/ S4.55- Phase 2 - Drop off Diagram

Materiality

/ S4.55 - COLA 3D View - Columns Hybrid timber/Steel composition

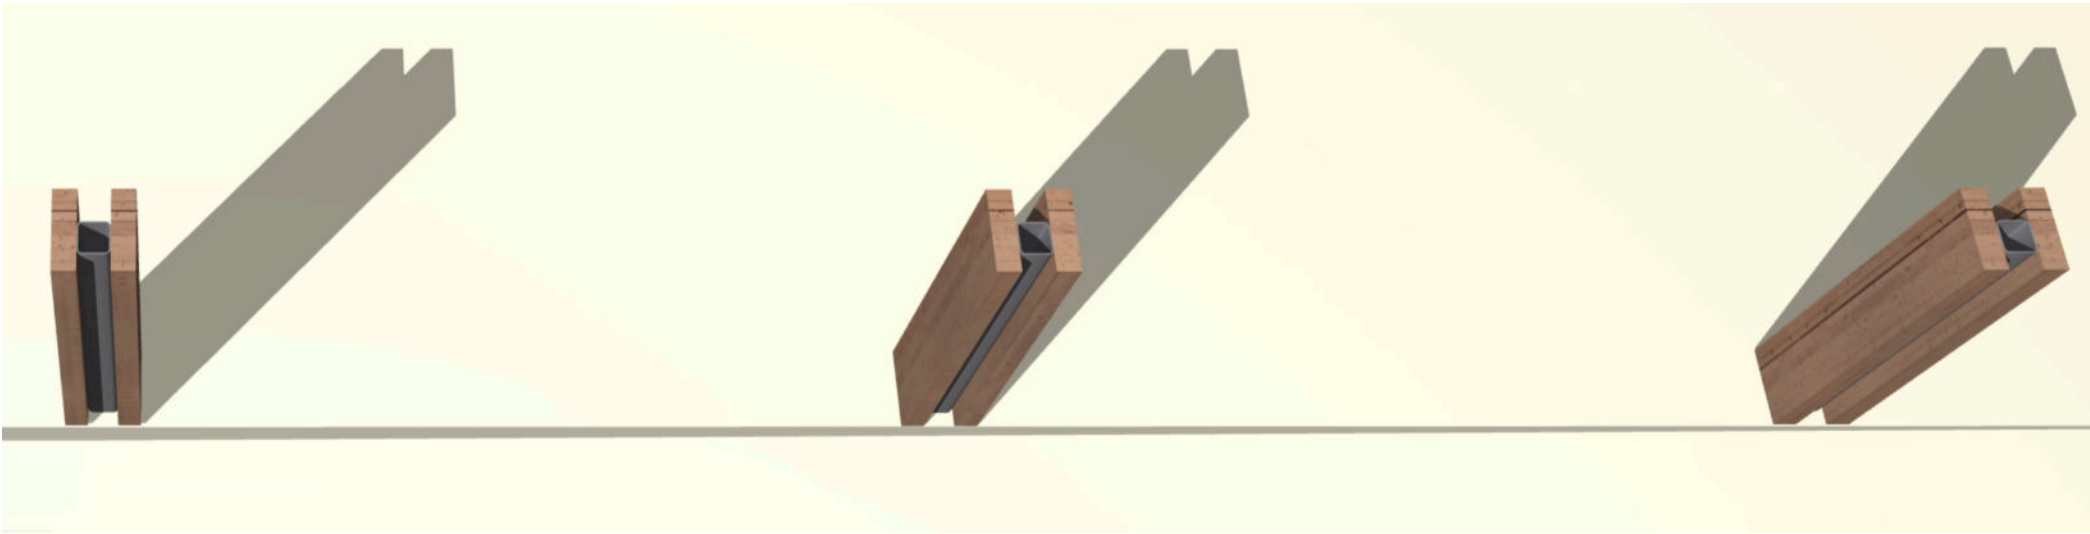
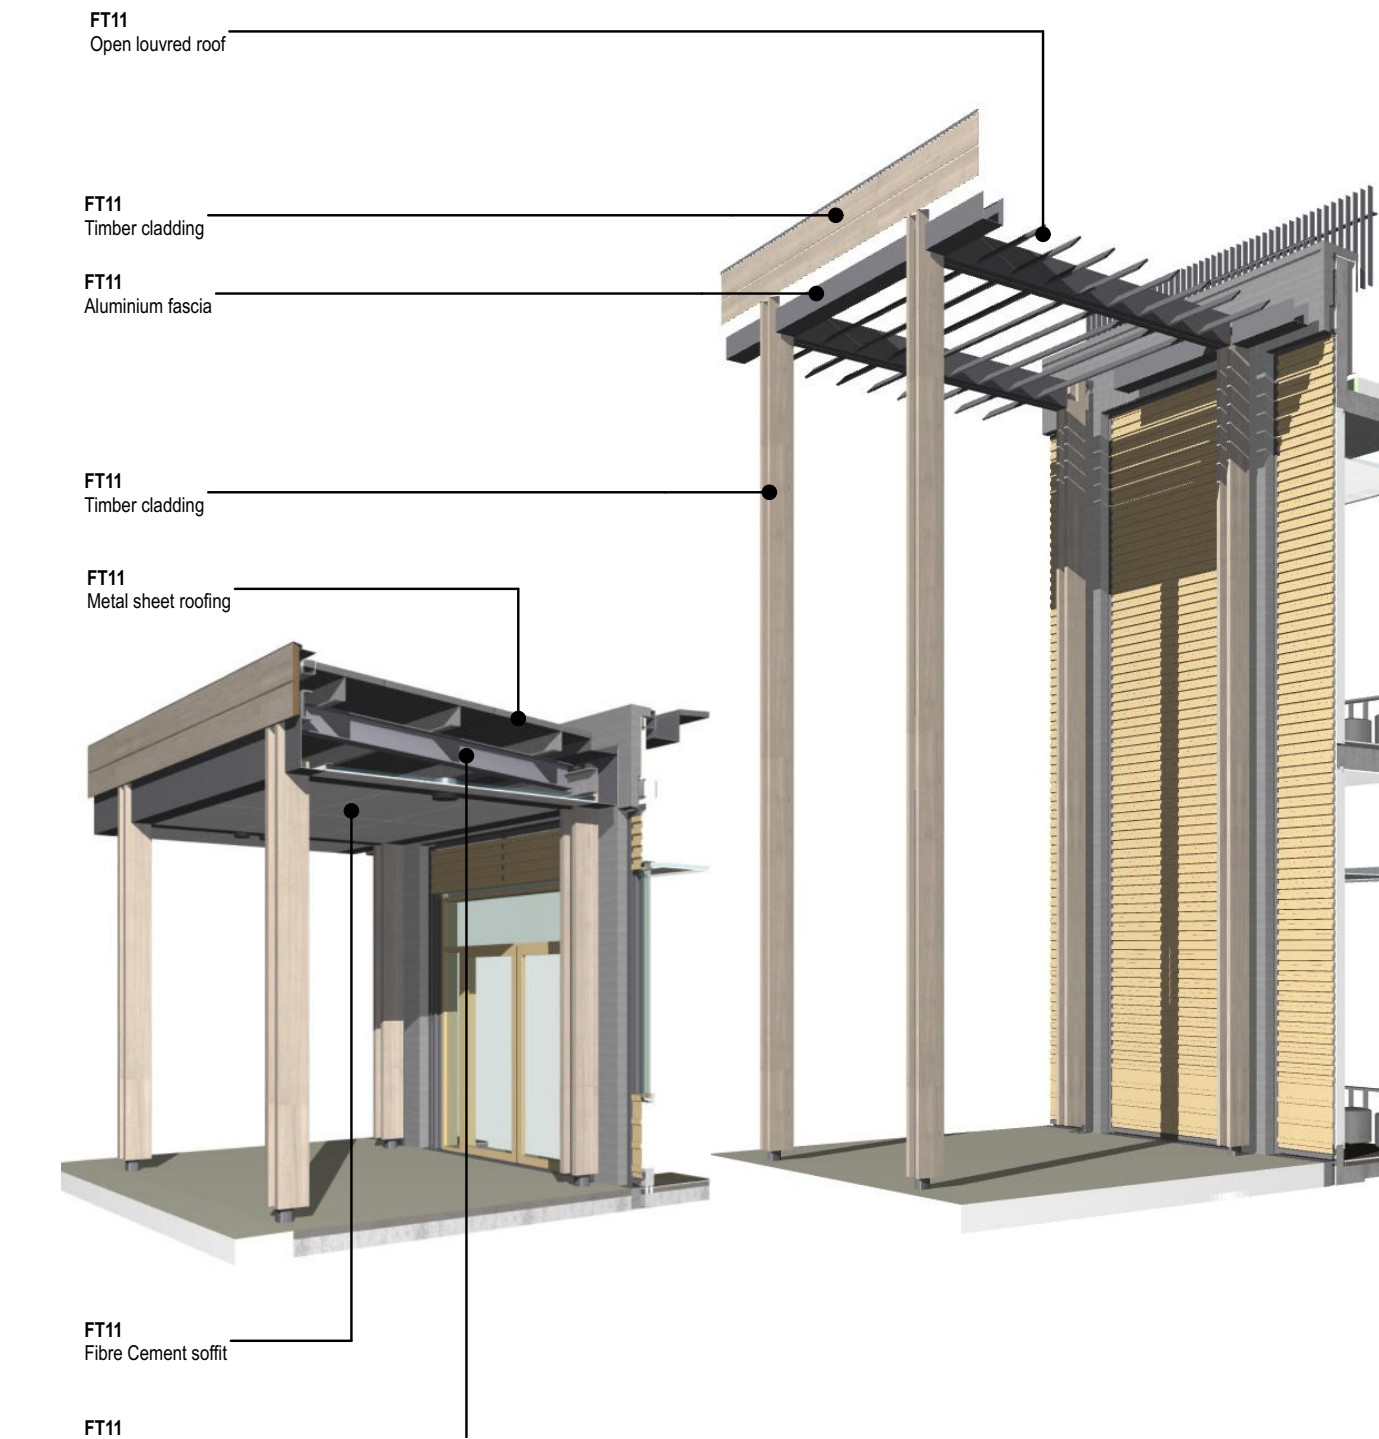
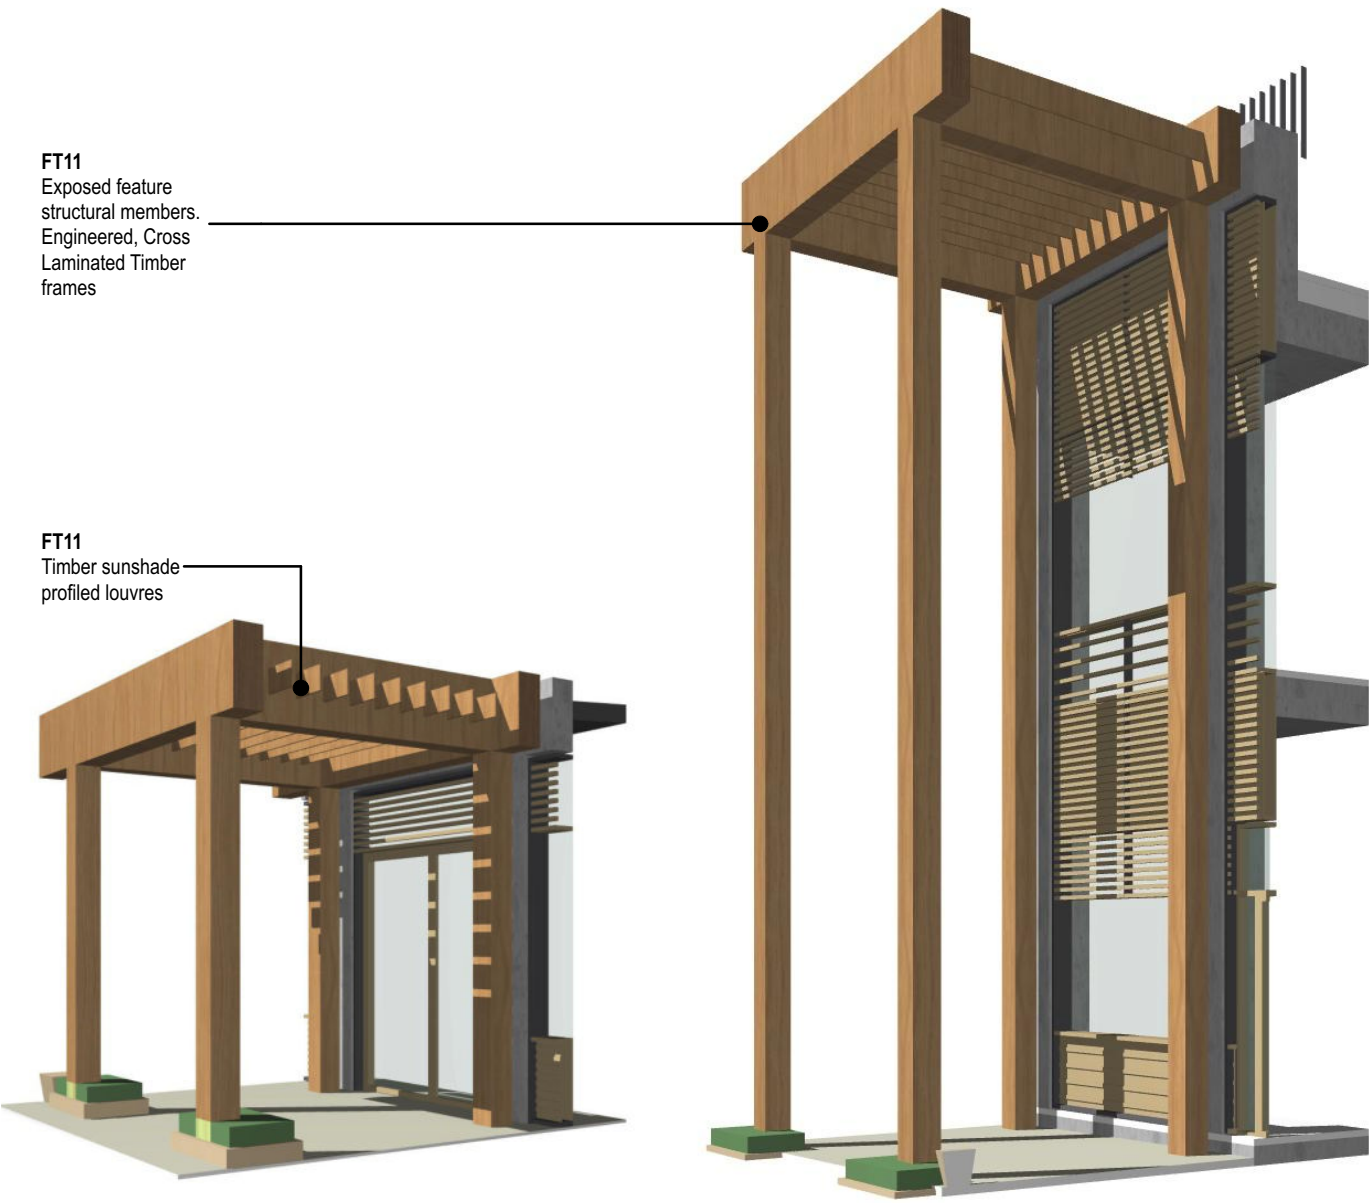
A hybrid steel / timber framed alternative has been proposed. Structural elements shall be realised in steel with a high-quality paint finish enabling an economy of fabrication, connection and section sizes. The structural steelwork finish shall be a highly durable Interthane industrial paint system. The system is especially formulated and designed for areas where a high wearing finish is required. It is a versatile coating delivering long term performance and is excellent in locations with aggressive environmental factors including high levels of exposure to solar, thermal, wind and salts.

The feature timber finish shall be sourced from a range of natural, true timber based products and is proposed to be unstained to allow the timber to age and develop a grey or silvered appearance; no stains are proposed to also limit the amount of ongoing maintenance required.

Facade Type 12 - Services Enclosure

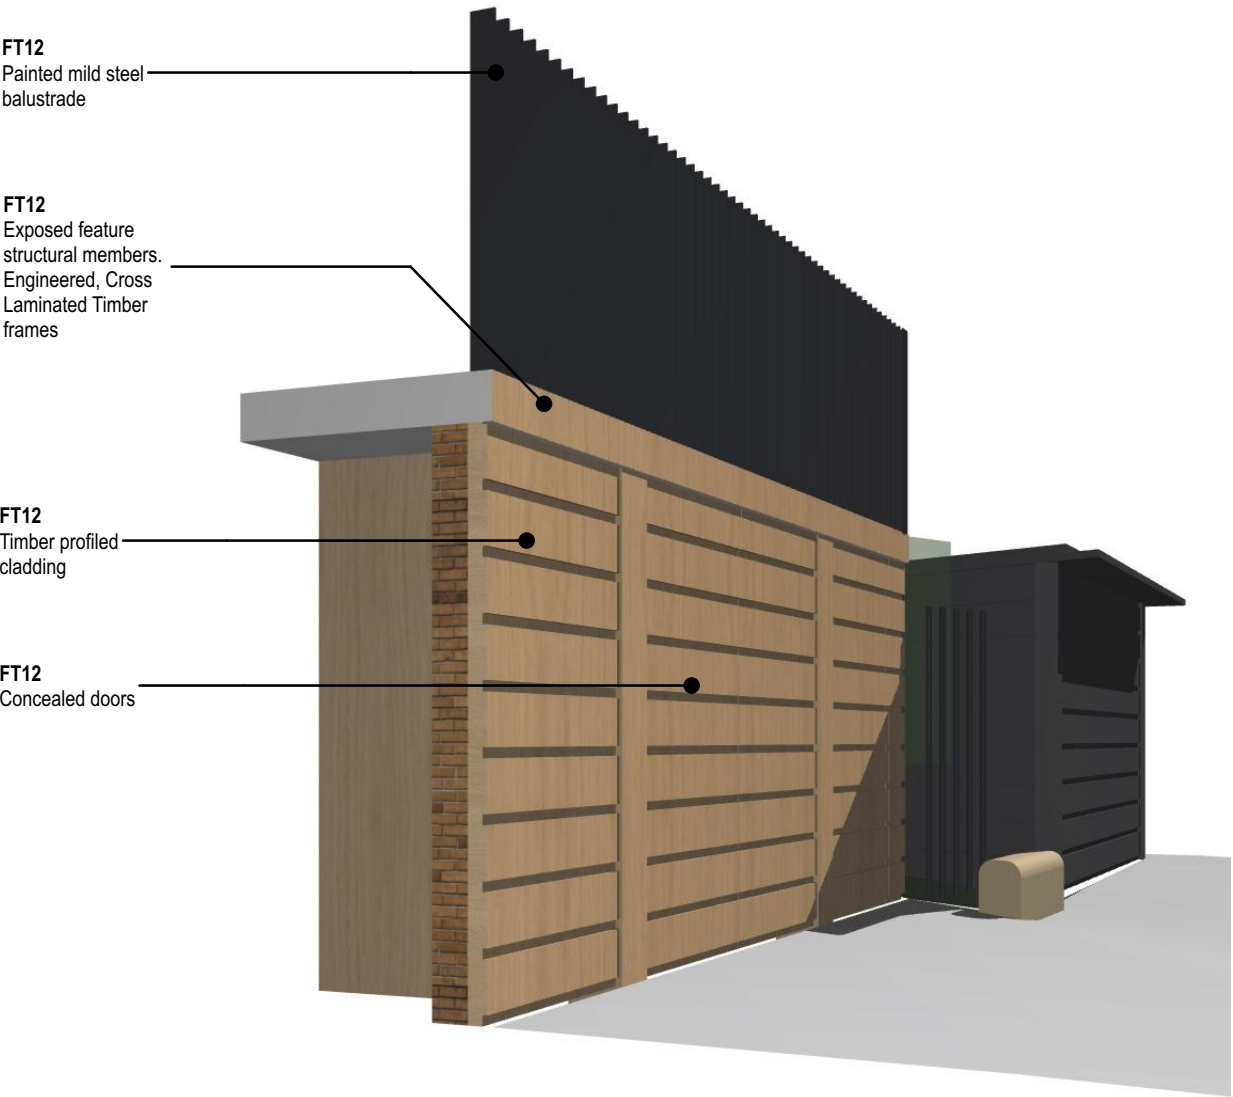
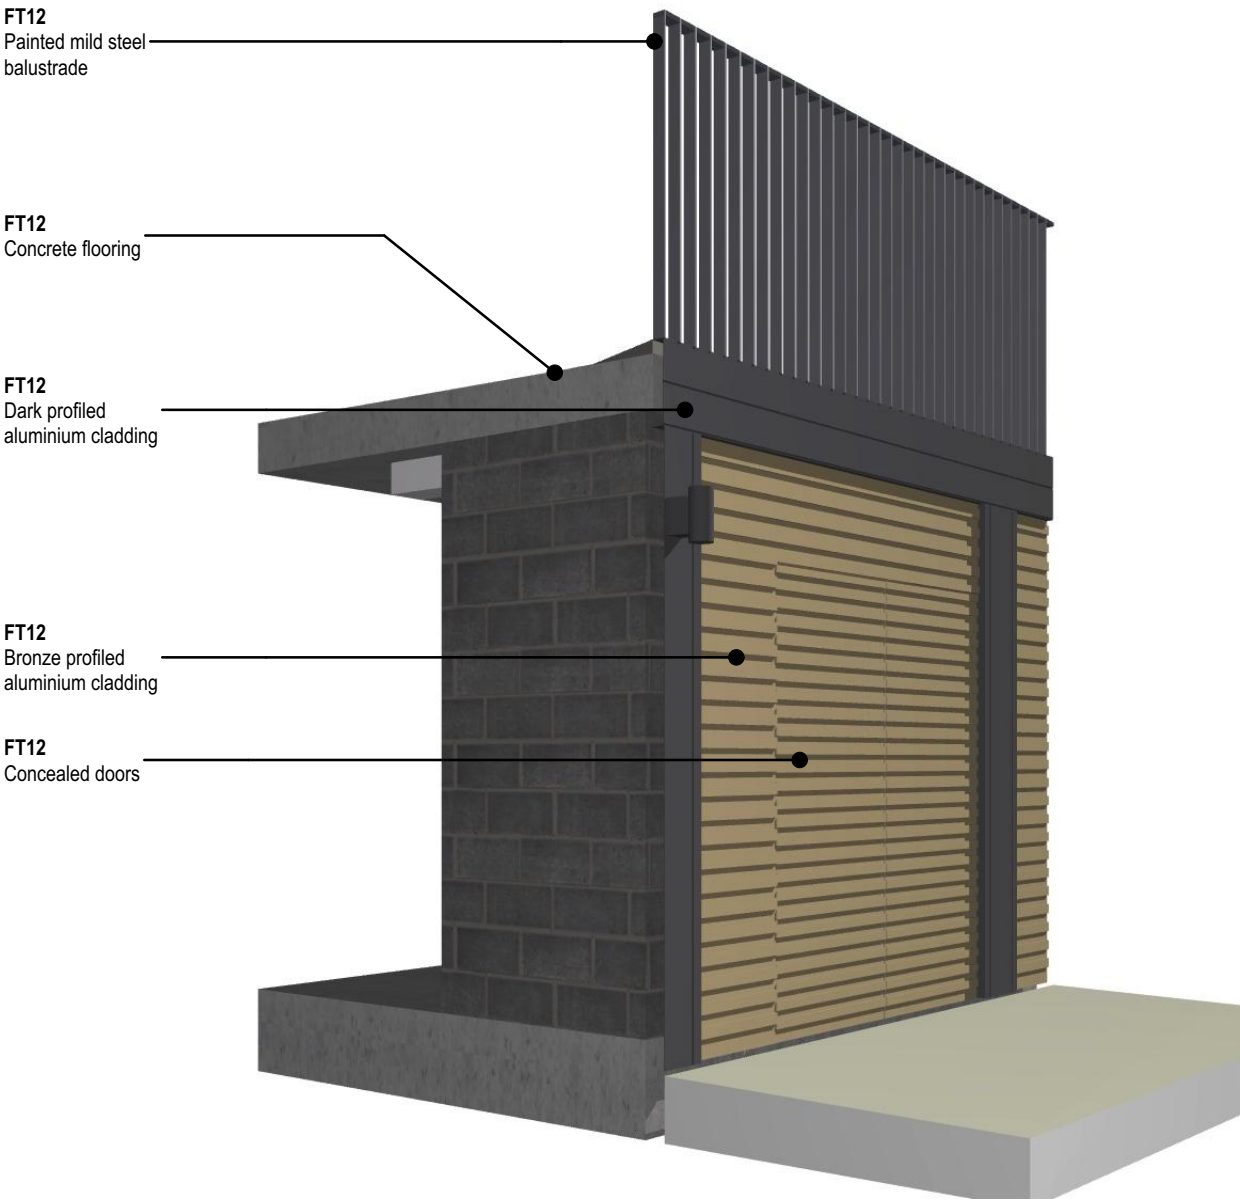
FT11	C.O.L.As	— Revised Materiality — Solid ceiling/soffit and Roof for one-storey C.O.L.As
FT12	Services Enclosure Facade	— Revised Materiality to Bronze Dark/Dark profiled aluminium cladding
FT13	Glass infills Facade	— Solid aluminium roof — Eave detailing revised

This diagram outlines the proposed alternative lighting design plan.

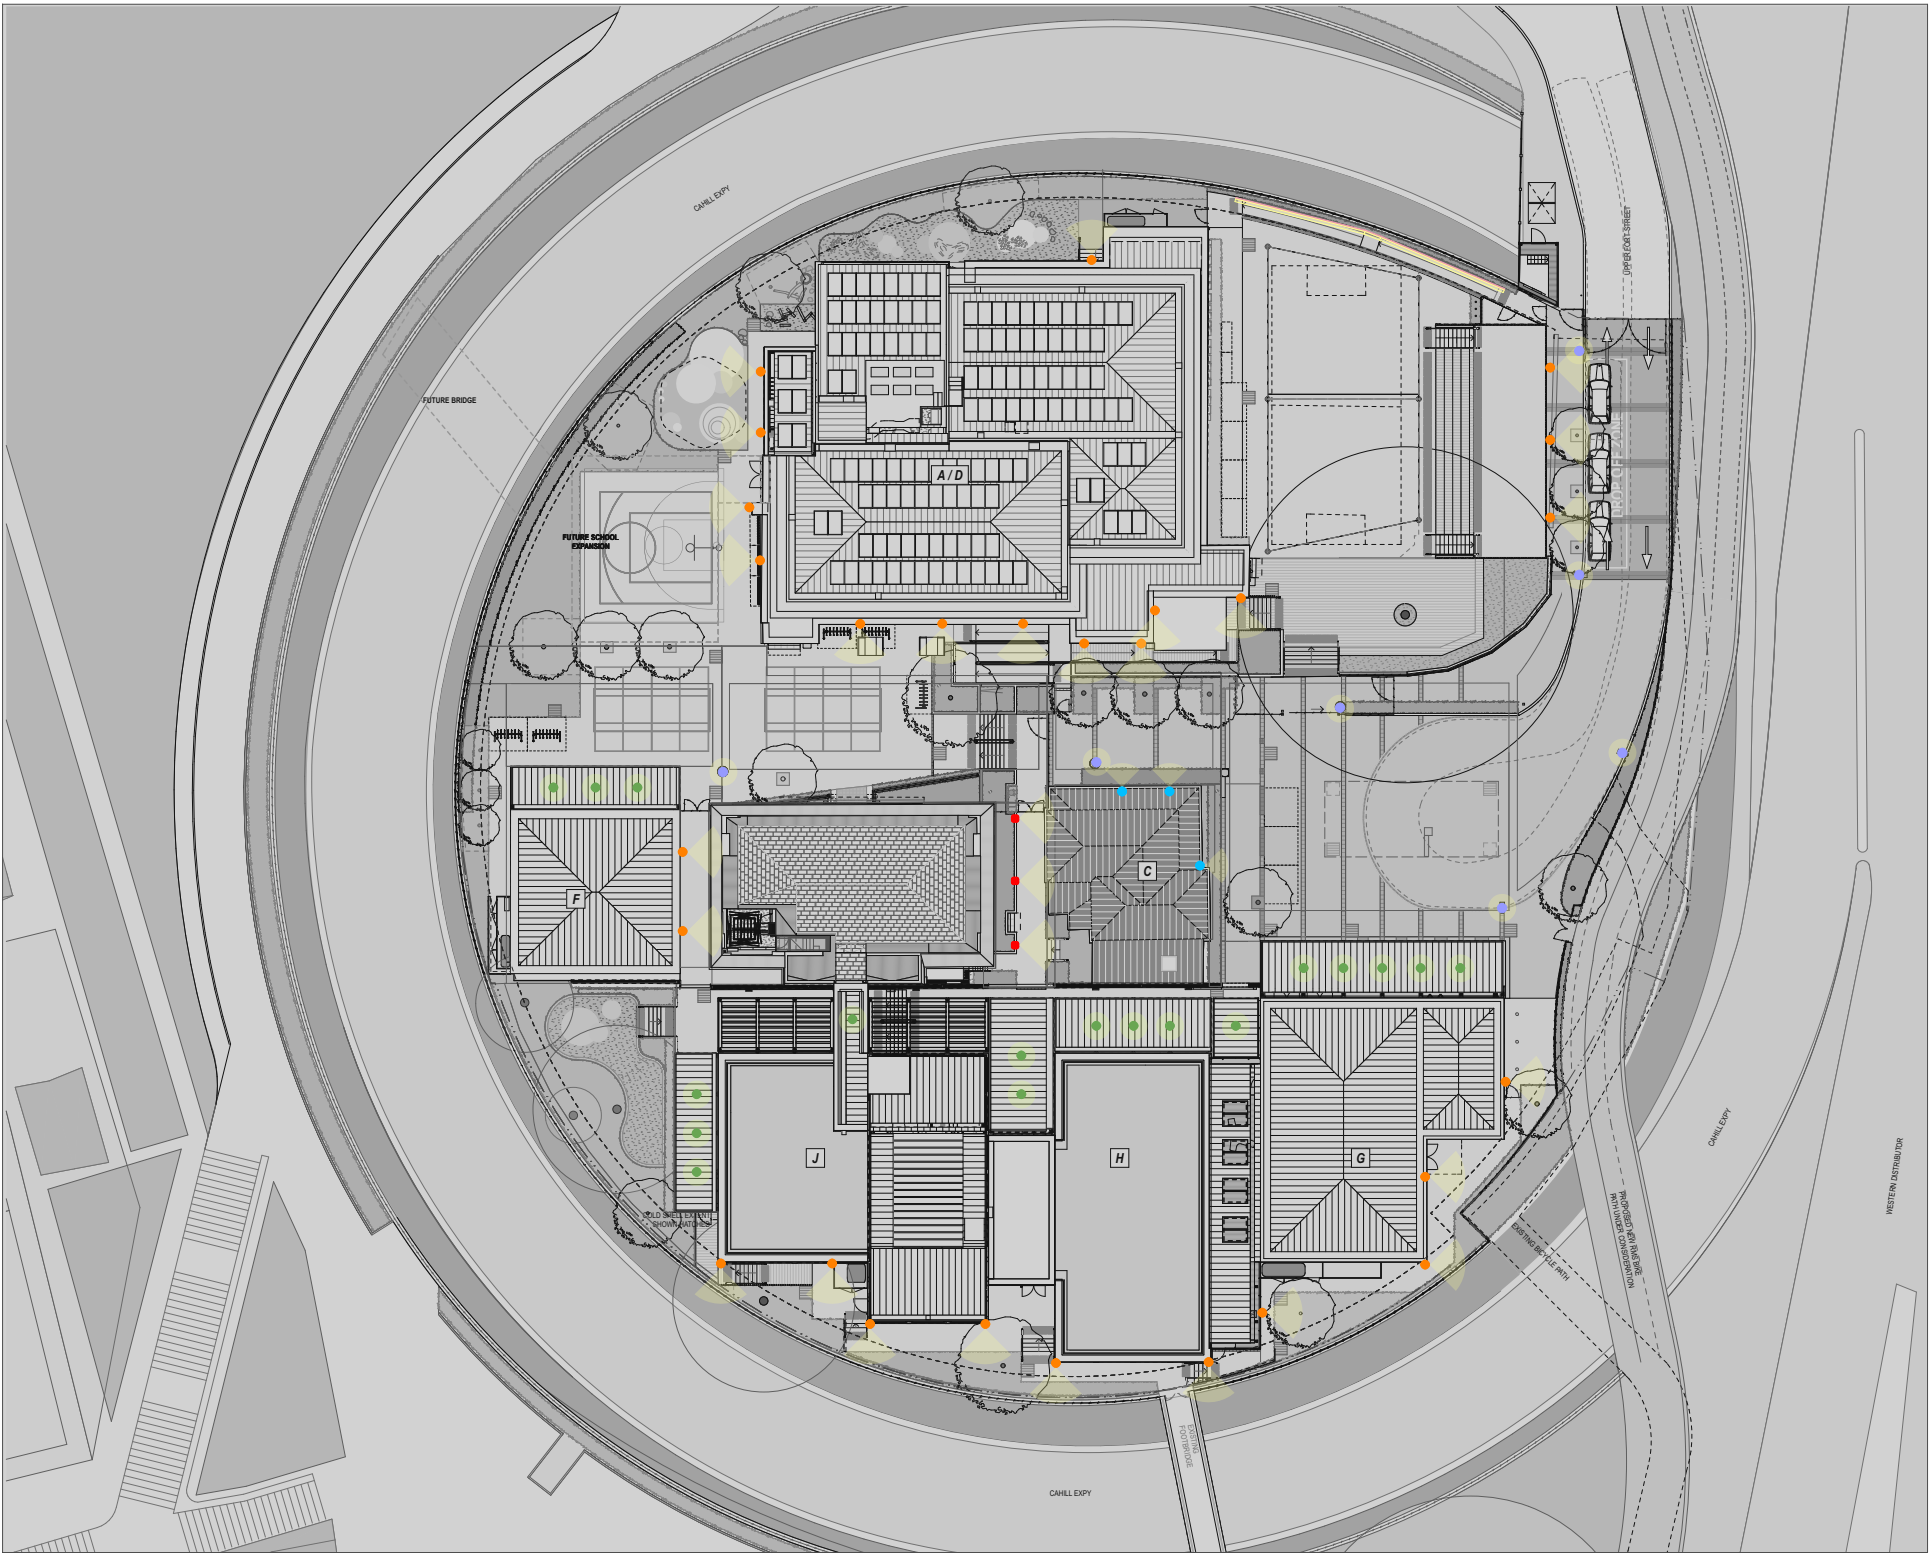
The project lighting strategy has been adjusted somewhat to address emergent site and project constraints associated with the previously proposed frequency of fittings, overall project cost and scope constraints. This has been achieved in conjunction with the requirement to maintain a low level of upward-facing light output and sensitive fittings selections, in order to respect the functionality of the adjacent Sydney Observatory.
